Date: November 14, 2005
Order No.: P-B-72.10/51
Supersedes:
Group: 72

**SUBJECT: Model 171.454/456/473
Wind Noise and/or Water Leak Between Door Glass and Rear Quarter Window**

Figure 1 P-B-72.10/51

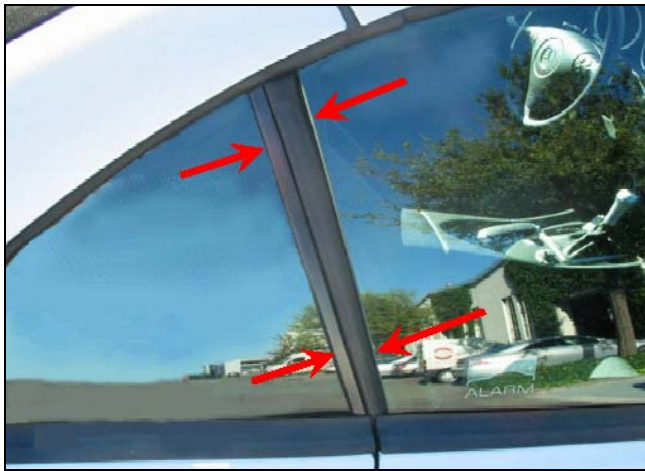
If you receive customer reports in the above model vehicles regarding wind noise and/or water leak from the area between the door glass and the rear quarter window, this may occur if the gap between these windows is not parallel or even (Figure 1, arrows) when the windows are fully closed. The non-parallel or uneven gap can occur if either or both windows are adjusted too far rearward. To resolve, perform the below adjustments.

Figure 7 P-B-72.10/51

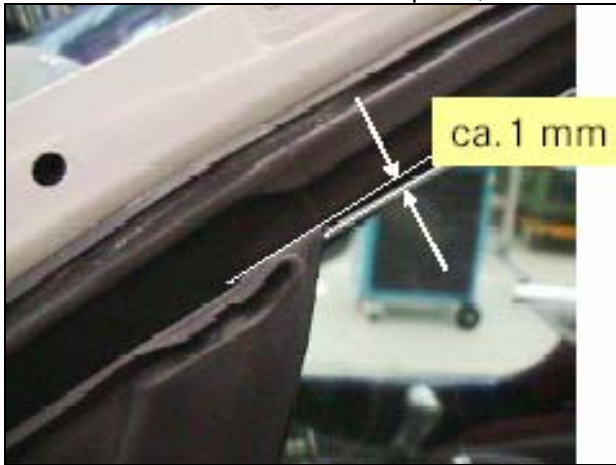
10. With the door and window closed, move height adjustment stops into position from inside the vehicle by pressing the quick release fitting (Figure 6, circle – only front adjuster shown) upwards.
11. Check the Z-dimension (protrusion of the side window relative to the mirror triangle 1 mm (Figure 7 and 8). If the dimension is not okay, loosen the front clamping jaws with the window upwards.
12. With the door and window closed, push height adjustment stops (Figure 6, circle) upwards again from inside the car.
13. Reinstall interior door trim panel, refer to WIS Document AR72.10-P-1000V.

Figure 10 P-B-72.10/51

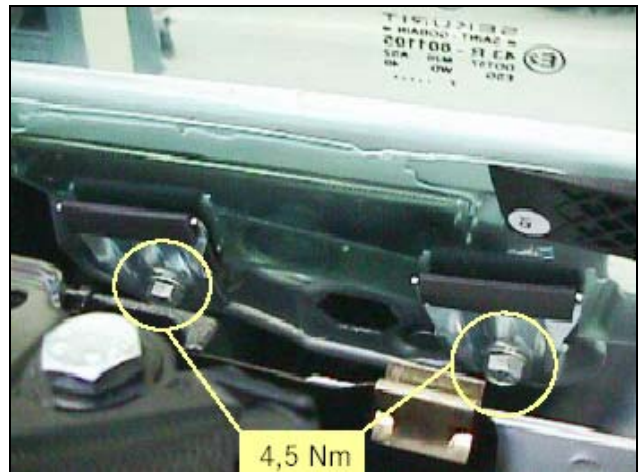
1. Open Vario Roof.
2. Detach trim at base of window.
3. Raise rear window using DAS actuations.
4. Check B-gap, should be 8.5 +1 mm (Figure 9).
5. If the B-gap is not okay, loosen bolts of clamping jaws (Figure 10, circles) and readjust rear window. Then retighten bolts (Figure 10, circles) to 4.5 +/- 0.5 Nm.

Figure 11

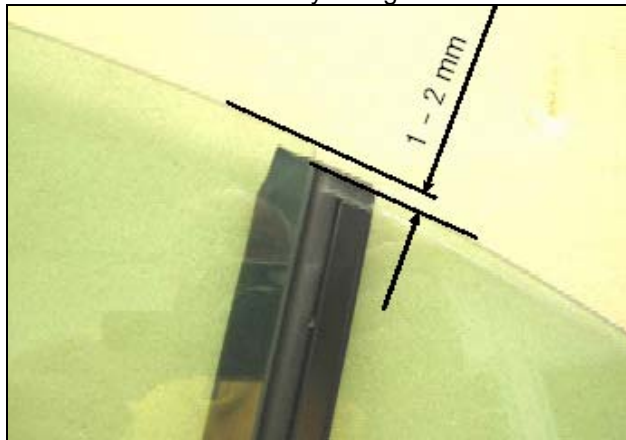
6. Check transition from door window to side window in Z-direction (Figure 11). The front edge of the door window must be set approximately 1 to 2 mm lower than the top edge of the side window.
7. The Z-direction setting is adjusted via the height stops (Figure 12, arrows); the direction of adjustment is indicated by the arrows. The rear side window must be lowered again using DAS actuations in order to obtain the maximum range of adjustment for the height stops. Then loosen the bolts for the height adjustment stops by turning the bolt clockwise (Figure 13, circle) and adjust the
